Proposed amendment to document ECE/TRANS/WP.29/GRSP/2012/12

The text reproduced below was prepared by the secretary from the UN Global Technical Regulation (UN GTR) on safety of hydrogen fuel cell vehicle aim to reflect the result of hydrogen vehicle working group and correct to appropriate wording, i.e. editorial and clarification.

The modifications to the text of ECE/TRANS/WP.29/GRSP/2012/12 are marked in highlighted in yellow or marked as strikethrough.

Figure 7

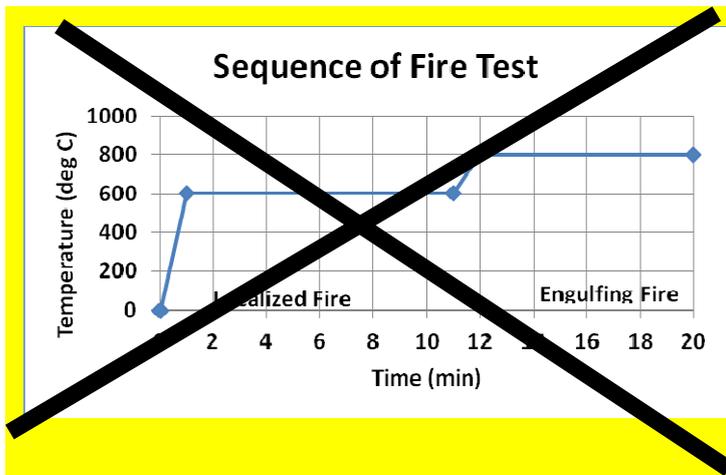
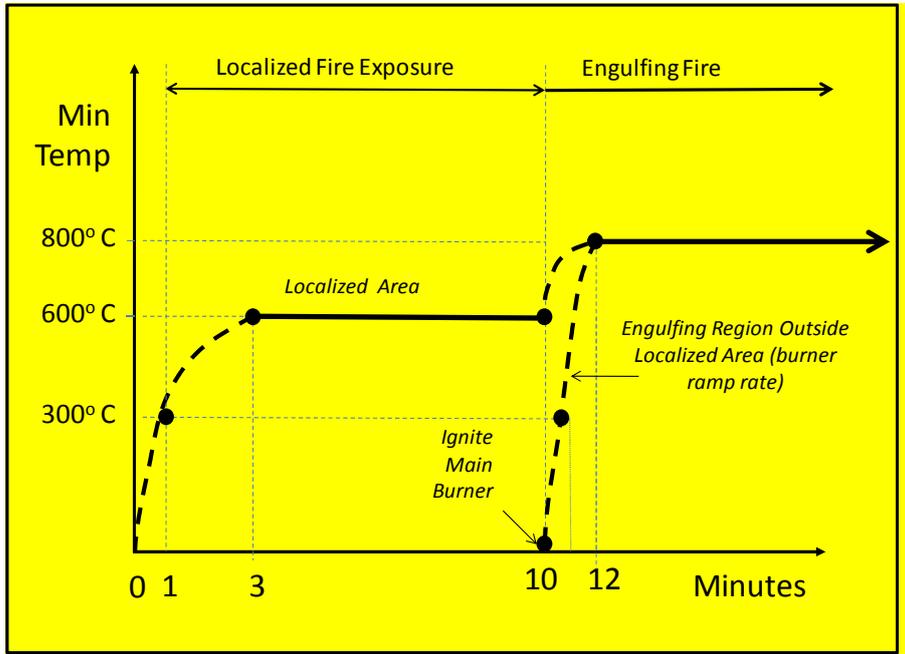
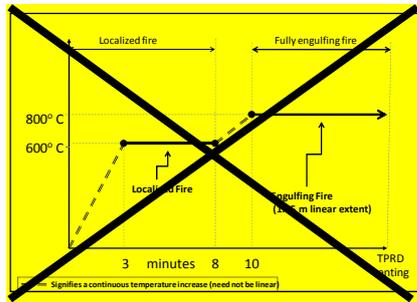
(f) As shown in Figure 7 the temperature of the thermocouples in the localized fire area has increased continuously to at least ~~300 °C~~ ~~within 1 minute of ignition, to at least~~ 600 °C within 3 minutes of ignition, and a temperature of at least 600 °C is maintained for the next ~~5-7~~ minutes. The temperature in the localized fire area shall not exceed 900 °C during this period. Compliance to the thermal requirements begins 1 minute after entering the period with minimum and maximum limits and is based on a 1-minute rolling average of each thermocouple in the region of interest. (Note: The temperature outside the region of the initial fire source is not specified during these initial 8 minutes from the time of ignition.)

~~The below profiles for fire time are being considered by SGS group:~~
